December 16, 2006

RE: Response to PLUS Review Comments; 2006-04-05
Georgetown Hunt

PRELIMINARY PLAN
PRELIMINARY SUBDIVISION PLAN
GEORGETOWN HUNT SUBDIVISION
FOR SPRINGFIELD WOODS, INC.
TOWN OF GEORGETOWN, SUSSEX COUNTY, DELAWARE

Map of Georgetown Hunt Subdivision as it impacts the wellhead protection area. The dark red area shows the wellhead protection area.

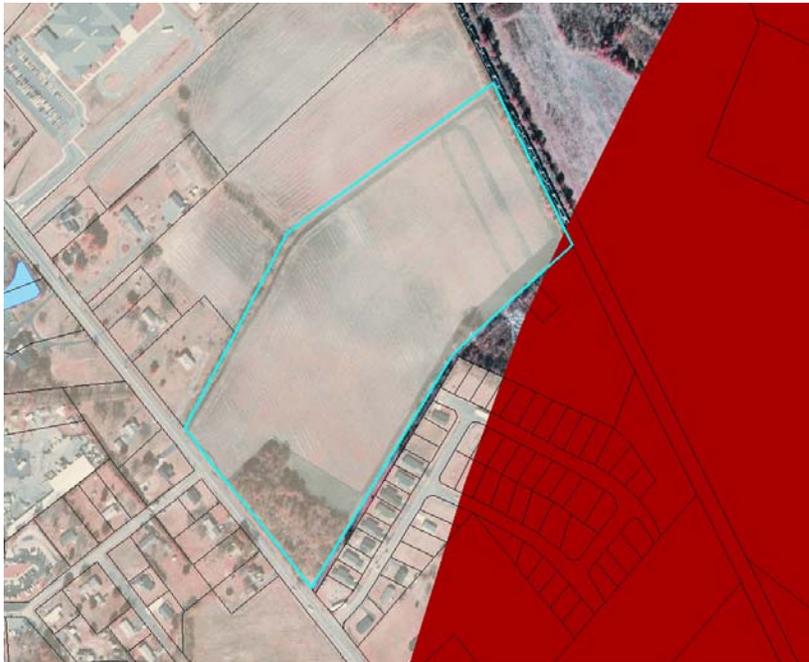
The DNREC Water Supply Section has determined that the project falls partially within a wellhead protection area for Georgetown (see following map and attached map). The southeast part of the parcel is partially covered by the wellhead protection area. Wellhead protection areas are surface and subsurface areas surrounding a public water supply well where the quantity and quality of groundwater moving toward such wells may be adversely affected by land use activities.

The development plan includes open space for passive recreation and storm water management. The wellhead area corresponds with open space containing a storm water management pond. This proposed use will have minimal impact.

The applicant concurs with the State's position that the project will have a minimal impact on the wellhead protection area.
